AUBURN HILLS 13TH ADDITION

RE: S/D 00-10 -- Final Plat of AUBURN HILLS 13TH ADDITION

At the regular meeting of the Subdivision Committee of the Metropolitan Area Planning Commission on Thursday, March 9, 2000, the above captioned plat was considered. The action of the Committee was to approve the final plat, subject to:

CASE NUMBER: S/D 00-10 -- AUBURN HILLS 13TH ADDITION

AUBURN HILLS 13TH ADDITION

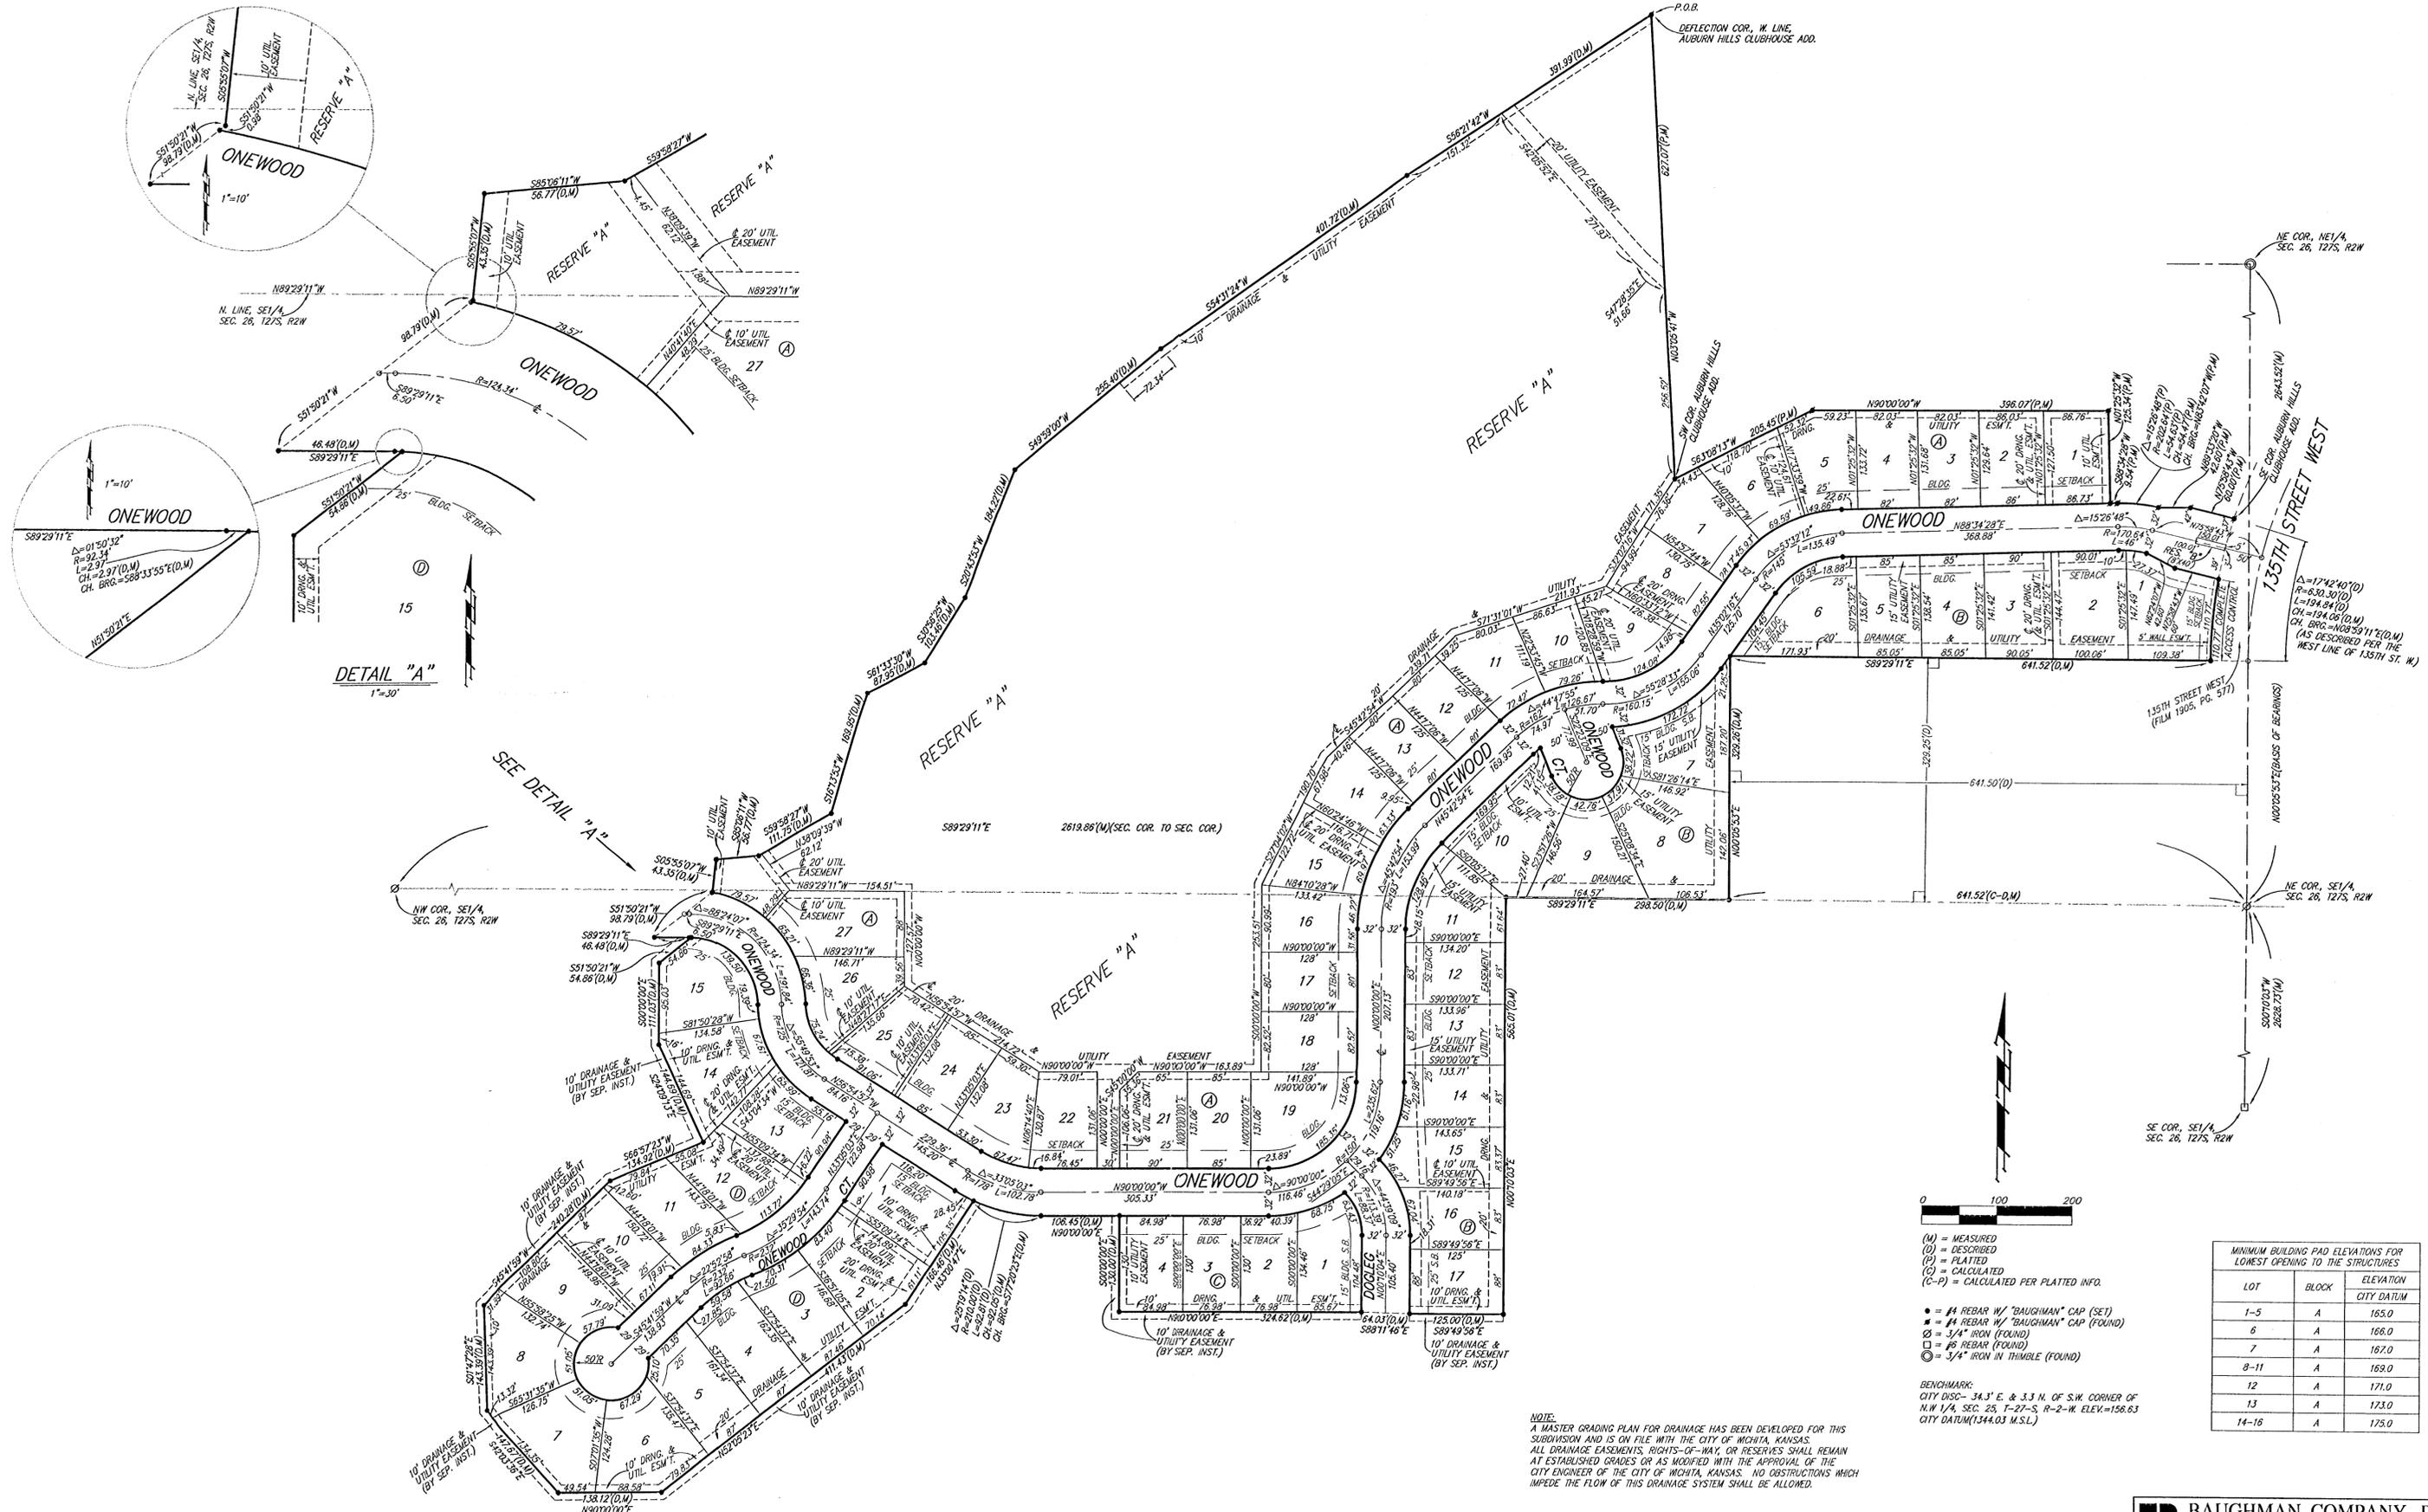
- D. If this site develops before Auburn Hills 12th, a temporary turnaround will need to be provided at the terminus of Onewood to the west and referenced in the plat's text on the final plat.

- I. A definite location needs to be denoted for the utility easement in the northeast portion of Reserve A.
- J. A definite location needs to be denoted for the utility easement northeast of Lot 27, Block A, in Reserve A.

- K. The centerline of Dogleg Street needs to be located at Onewood Street.
- L. Bearings needs to be added for the north line of Lot 1, Block B.
- M. The Applicant is reminded that a platting binder is required with the final plat. Approval of this plat will be subject to submittal of this binder and any relevant conditions found by such a review.
